**JOINT REGIONAL PLANNING PANEL
(Sydney West Region)**

JRPP No	2014SYW090
DA Number	0180/14
Local Government Area	Ku-ring-gai Council
Proposed Development	Demolish existing structures and construct a mixed use development containing 3 buildings, 144 residential apartments, retail space, basement parking and landscaping works
Street Address	870-898 Pacific Highway, Gordon
Applicant	Alto Prestige Pty Ltd
Owner	Alto Prestige Pty Ltd Georgio Altomonte Holdings Pty Ltd
Number of Submissions	Original proposal – 3 submissions Amended proposal – 1 submission Further amended proposal – 1 submission
Recommendation	Refusal
Report by	Grant Walsh, Executive Assessment Officer

Figure 2.0 – Source – Clause 4.6 prepared by Ryan Planning, dated July 2015

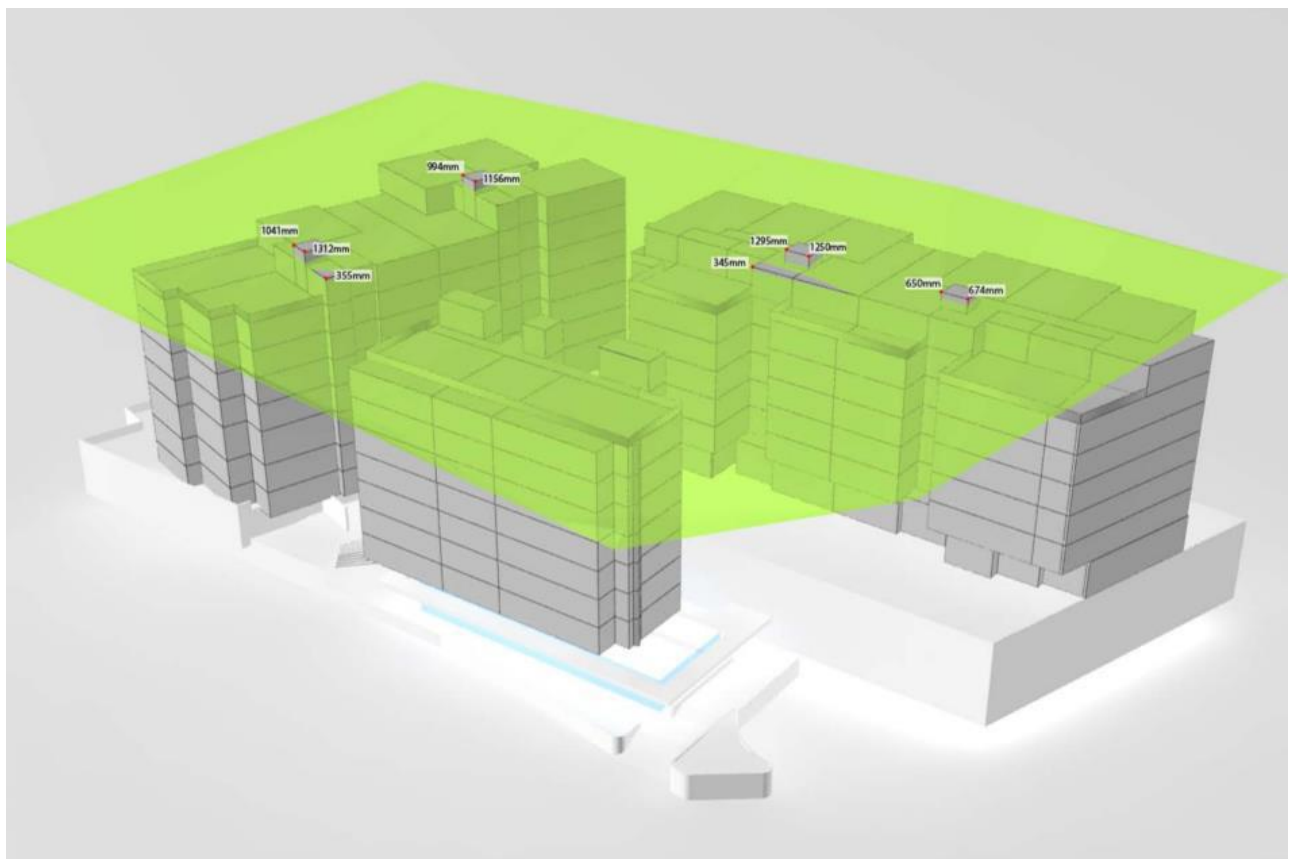
The applicant has further argued that there are sufficient environmental planning grounds to justify contravention of the development standard demonstrating that the proposal would comply with an interpolated ground line with the exception of minor breaches to a maximum of 1.295m associated with a lift overrun as demonstrated in **Figure 2.0** below, and the lack of impacts associated with the breach.

It is noted that there are no discernible impacts that arise as a result of these height breaches (above the interpolated ground line or the height plane as defined by the LEP). The reasons/justification put forward by the applicant are well founded and are accepted in this case.
